Access Compliance Report

Public Rights-of-Way

(Curb Ramps)

Intersection ID: 10037289	Main Street: SARDIS_RD_NORTH	Cross Street: N/A	Location: SW
ADA ID: AE4D67748B7B	Ramp Type: Perp	Initial Pass/Fail: Fail	Overall Compliance: No
Severity Score: 21.25			
Codes/Mitigation Info/Possible Solution		Field Measurements/Component Compliance

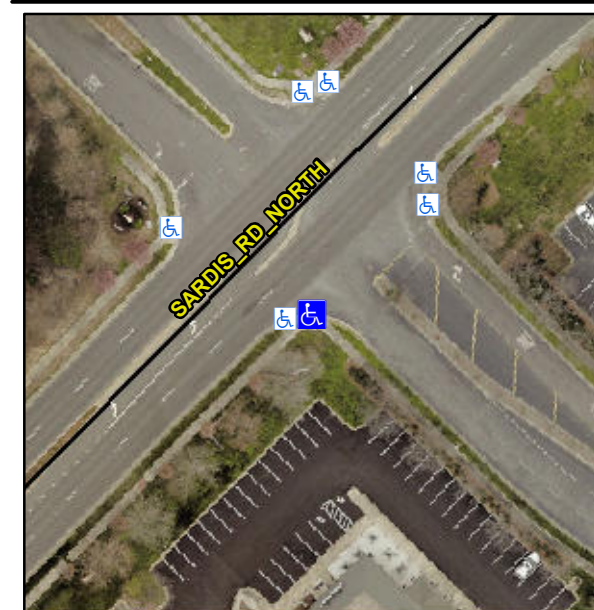
Not Found, R304.5.1, R304.2.2

Compliance	Description	Data	Compliance	Description	Data
N/A	Ramp Length (in)	76.0	No	Ramp Slope (%)	8.6
No	Ramp Width (in)	36.0	Yes	Ramp XSlope (%)	1.4
N/A	Flare Type LT	N/A	N/A	Flare Type RT	N/A
N/A	Flare Slope LT (%)	N/A	N/A	Flare Slope RT (%)	N/A
N/A	Flare Traversable LT?	N/A	N/A	Flare Traversable RT?	N/A
N/A	Landing Length (in)	N/A	N/A	DWS Provided?	N/A
N/A	Landing Width (in)	N/A	N/A	DWS Contrast?	N/A
N/A	Landing Slope (%)	N/A	N/A	DWS Length (in)	N/A
N/A	Landing X Slope (%)	N/A	N/A	DWS Full Width?	N/A
N/A	Landing Curb? (Y/N)	N/A	N/A	DWS Offset (in)	N/A
N/A	Shared Landing?	N/A			
N/A	Gutter Ponding?	N/A	N/A	Gutter Slope (%)	N/A
N/A	Gutter Lip Ht (in)	N/A	N/A	Gutter X Slope (%)	N/A
N/A	Painted X Walk1?	No	N/A	Painted X Walk2?	N/A
	X Walk 1 Direction	To NE		X Walk 2 Direction	N/A
N/A	X Walk 1 Width (in)	N/A	N/A	X Walk 2 Width (in)	N/A
	X Walk 1 Slope (%)	0.3		X Walk 2 Slope (%)	N/A
	X Walk 1 X Slope (%)	2.2		X Walk 2 X Slope (%)	N/A

Remove & Replace Entire Ramp.
